STAFF REPORT ACTION REQUIRED

Application for Encroachment Agreement 35 Riverview Gardens

Date:	March 16, 2008
To:	Etobicoke York Community Council
From:	Curtis Sealock, Manager, Municipal Licensing and Standards
Wards:	Ward 13 Parkdale – High Park
Reference Number:	ML&S Folder No. 07-253637 RAW 00 IR

Attachment 2: Site Plan

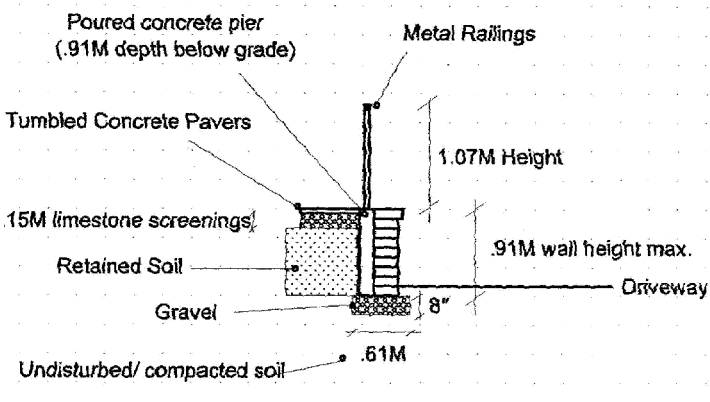
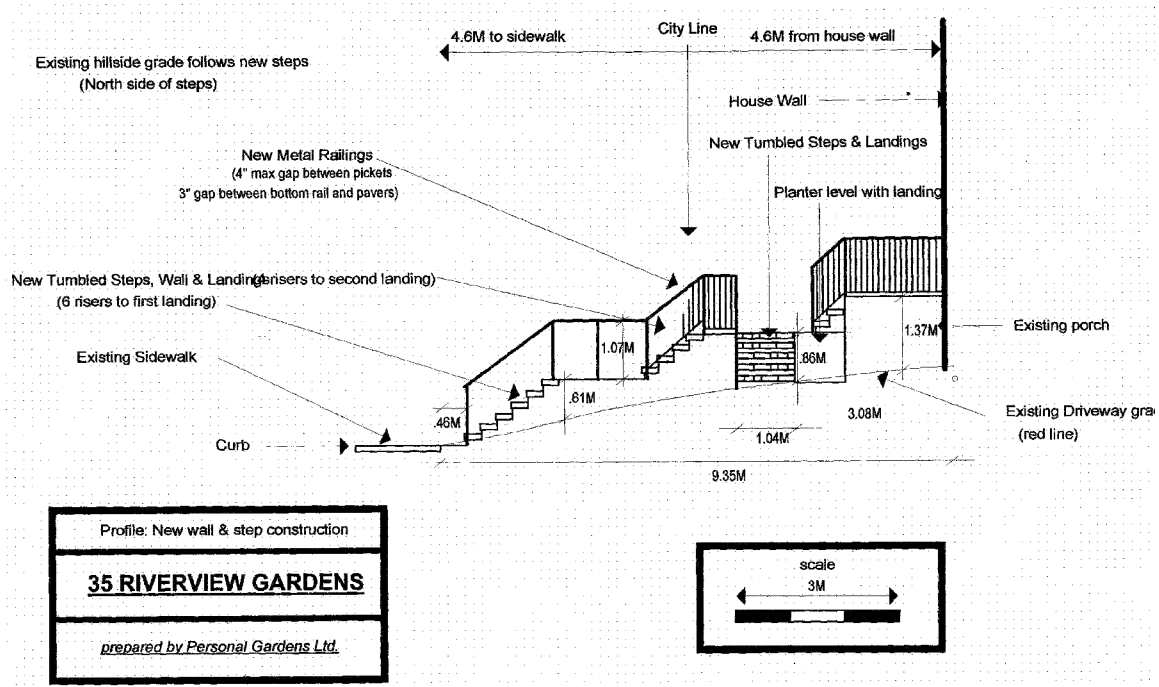
4. the Certificate of Insurance to be renewed on an annual basis for the life of the encroachments;
5. the proposed guards and handrails to be installed and maintained in accordance with the Ontario Building Code, including any similar additional guard protection as necessary to avoid falling off the proposed half landing at the front as well as the neighbour's retaining wall at 37 Riverview Gardens on the north side of the property (Attachments 1, 2 and 5);

6. the height of the proposed retaining walls shall not exceed 0.90 of a metre;
7. the retaining wall and planters shall be setback from the back edge of the sidewalk for at least 0.46 of a metre;

8. the footings of the proposed retaining wall shall not exceed 0.61 of a metre below the existing sidewalk;
9. there shall be no solid screen fencing along the Riverview Gardens frontage;

The existing guardrails and handrails along the north side of the steps will be relocated to the south side. While this will protect the occupants and visitors from falling off the new concrete retaining wall on the south side, the lawn on the north side of the steps will become accessible and this will create a hazard of falling over an unprotected 1.5 metres high retaining wall at the neighbour's property (37 Riverview Gardens) (Attachments 2 and 5). Guard protection will be required at this location. Also the half landing of the new steps will also need to be protected if the drop exceeds 0.60 of a metre. Installation of a guardrail on both sides of the steps will be a solution to this problem.

- (a) the height of the retaining walls shall not exceed 0.90 of a metre;
- (b) a 0.46 of a metre clearance setback from the back edge of the sidewalk shall be maintained;
- (c) footings shall not exceed 0.61 of a metre below the grade of the existing sidewalk; and
- (d) no solid screen fencing shall be permitted along the Riverview Gardens frontage of the subject property.
